Caltrain Electric Train Reconfiguration & Our Rebuttal to Staff's One-sided Presentation

BIKES ONboard Project

Updated May 19, 2019

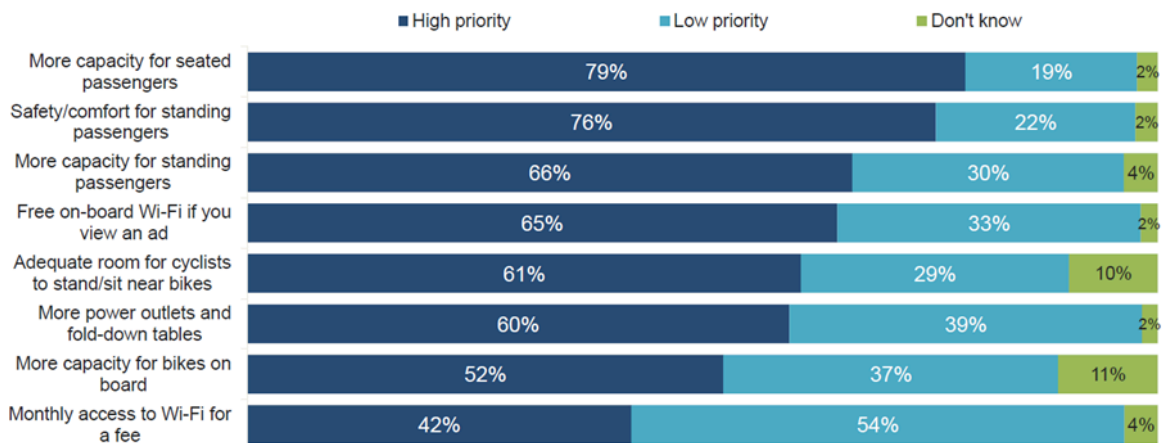
Slide 30: This rider survey was an opt-in survey. While it may be statically accurate, it is not statistically significant because it is not a random sample of all riders. The results should be taken with a grain of salt.

Riders Priority for New Electric Trains

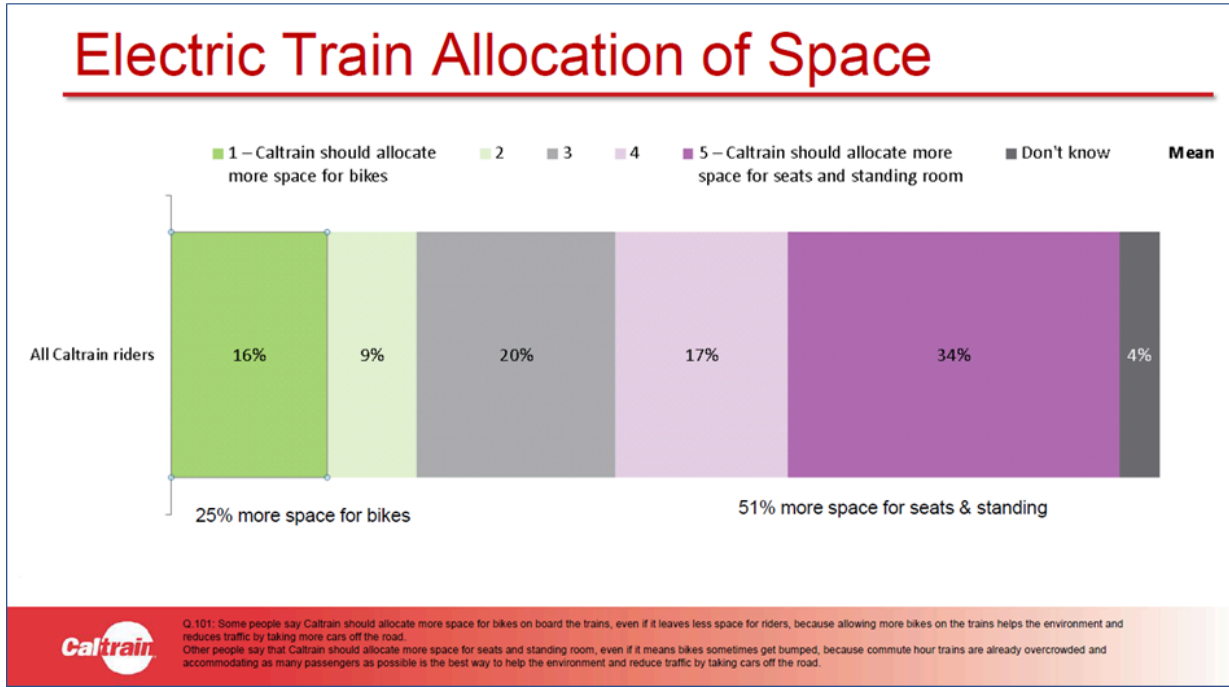
Slide 31: There is widespread support for bikes on board from the general ridership. While approximately 10% of passengers bring a bike on board, over half of passengers consider it high priority to have more

capacity for bikes on board. The survey question is unknown as it got cut off the bottom of the slide.
 Reminder: This survey is statistically insignificant.

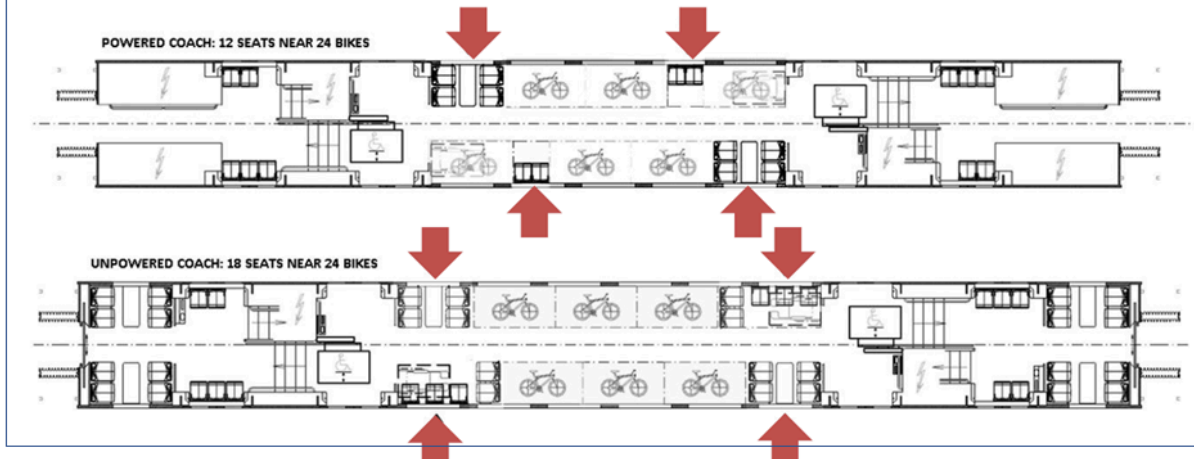
Slide 32: Caltrain conducted an online push poll that pitted passengers against each other. As intended with a push poll, Caltrain got the response they were seeking to support their predetermined intention to decrease bike space compared with today. The survey question is written in fine print at the bottom of the slide. It reads:

Instead of pitting passengers against each other, Caltrain should focus on serving the needs of all passengers. Reminder: This survey is statistically insignificant.

Option 1: Two bike cars, no reconfiguration (current design)

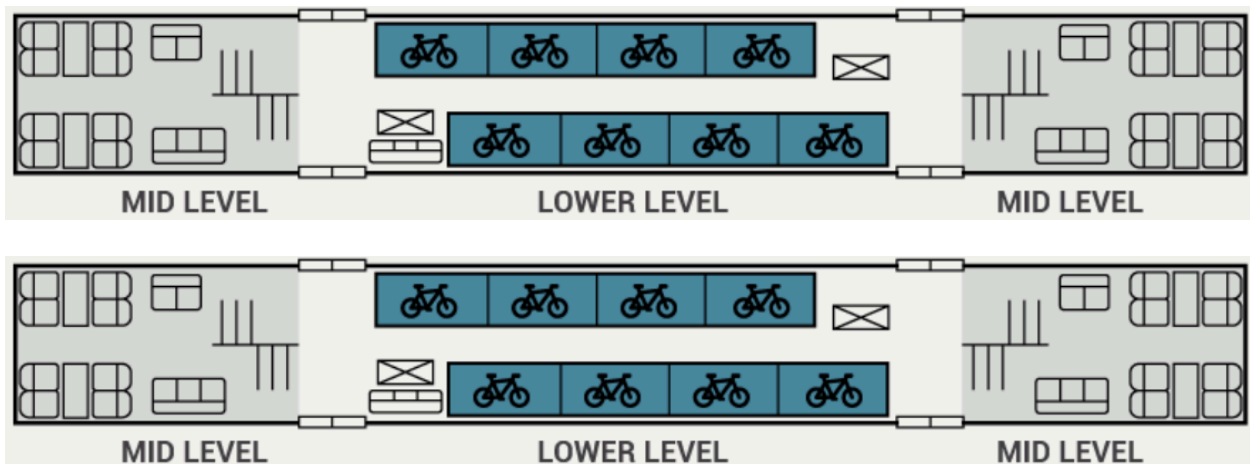
The current design has no fixed seats within view of bikes. Two bike cars hold 36 bikes each (four on each rack) for 72 bikes per train. One of the bike racks is at the same location as wheelchair space (marked with an x in a rectangle). The other wheelchair space has three folding seats.

Option 1 is a throw away. The current design encourages bike theft. Caltrain took no public input on this design, and it took over a year of public outcry about bike theft to get Caltrain to finally reconsider. Problems with option 1 is the whole reason Caltrain agreed to hold a workshop.

Option 2: Reconfigure two bike cars

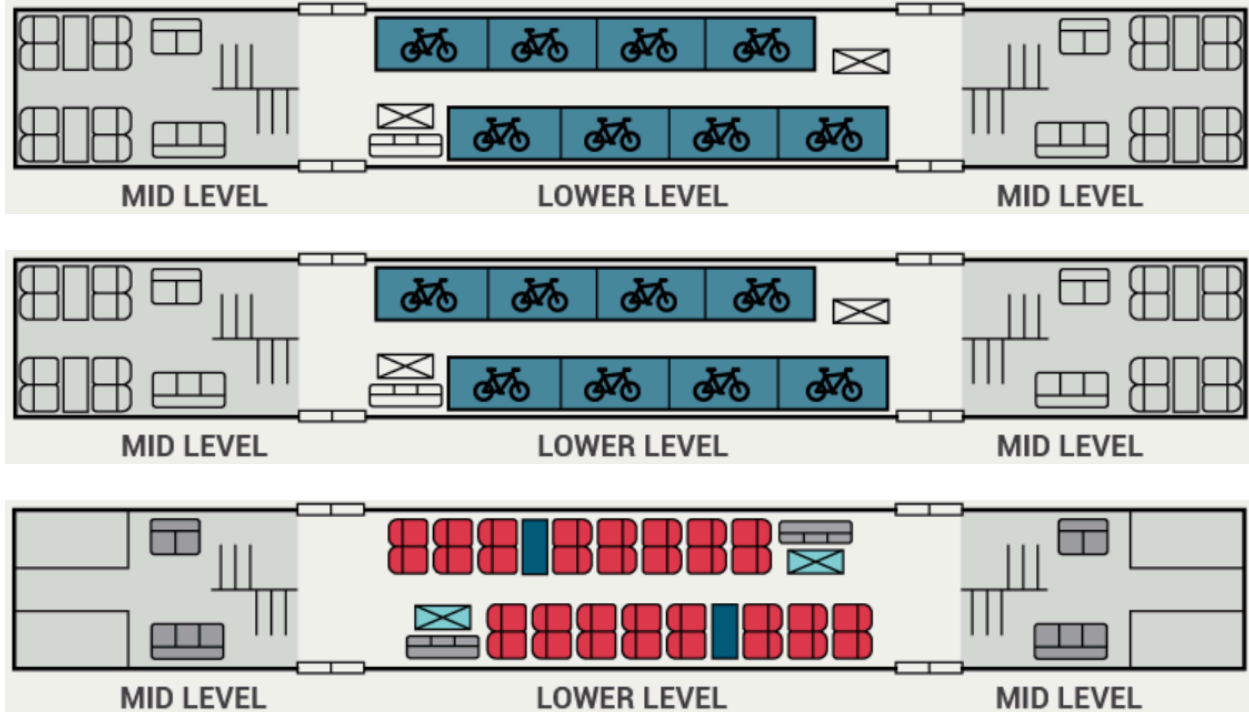
Option 2 is a non-starter. The only way to put seats within view of bikes is to remove bike racks to add seats in each bike car, reducing bike capacity. EMU trains already have fewer bike spaces (72 per train) than today's diesel trains (77 per train). Reducing bike capacity even further would be an even bigger step backwards. Furthermore, this would not meet the board-mandated 8:1 ratio of seats-to-bike spaces.
